UNITED NUCLEAR CORP. LETTER DATED JULY 25, 1962 - DOCKET 70-36

We have reviewed the subject application requesting modified procedures for drying highly enriched UF_6 in the drying oven, and the addition of a new filter for UF_6 .

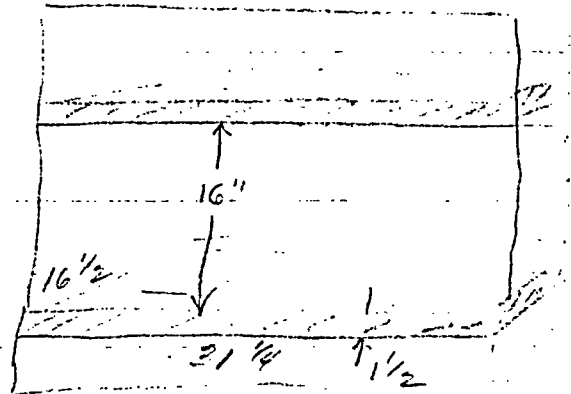
... Note: Sketch given 17" dia.
Add a new 5" dia x 12" VF₄ filter

Drying Oven - Dry VF₄ in two layers rather than one

Safe slab thk, opt mod is 1.5"

Green part will be wet but not opt

Brgh. Check 1019 (Very Conservative)

$$N = \frac{\text{Area}}{A^2} = \frac{16.5 \times 31.25}{16^2} = 2.01 \text{ slabs. UN gets 1.3 slabs.}$$

Note: K-1019(S) gives 12" spacing OK for two inf 1 1/2" slabs
i.e. Green is OK.
